CITY OF PROVIDENCE, RHODE ISLAND

RFP Title: HVAC and Electrical Upgrades at Two Fire Stations

Addendum #: 4

Addendum #4 – Responses to Bidder Questions

SCALE: 3/32"=1'-0"

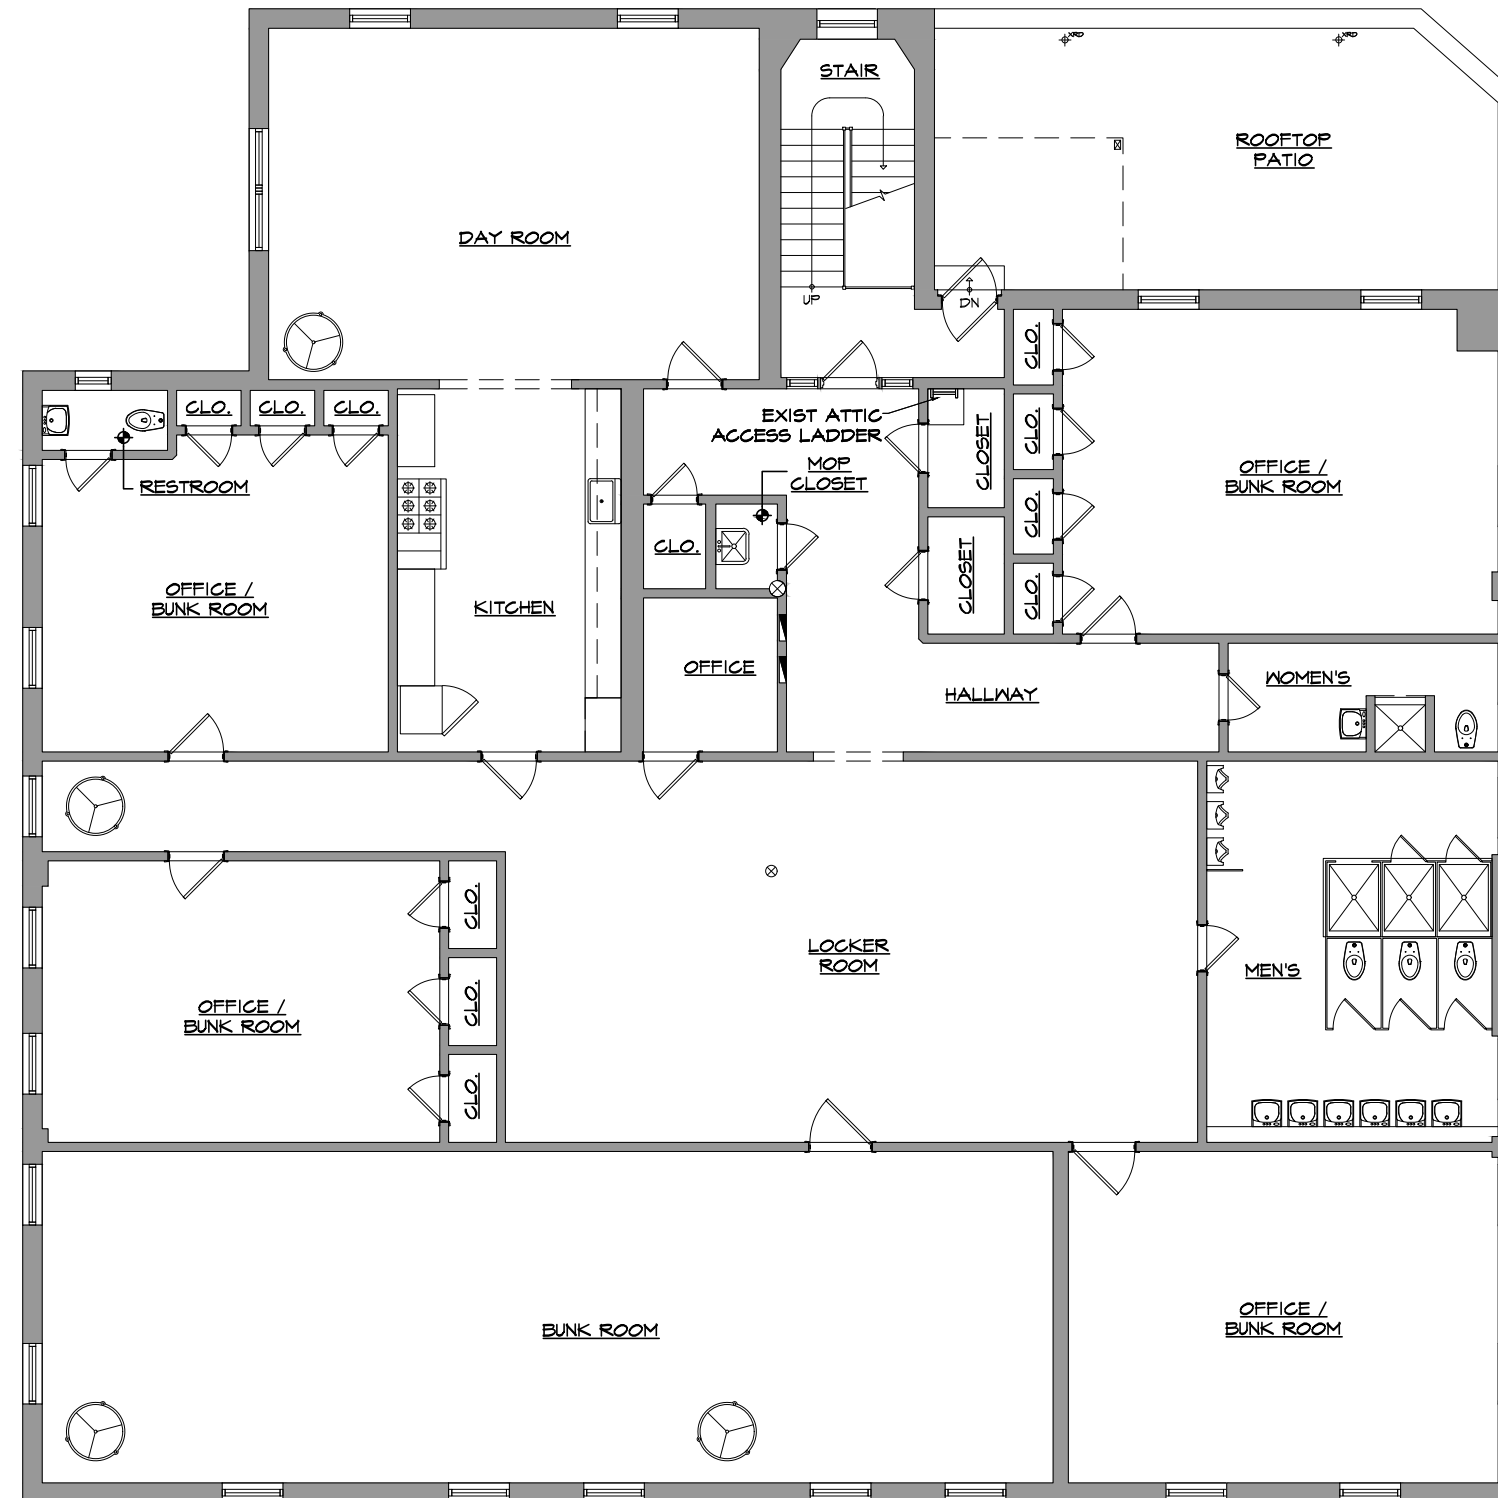
- 1) Are the Architectural drawings mentioned in the Plans available?

A: Basic floor plans developed during the fire station building evaluations are attached for bidder information.
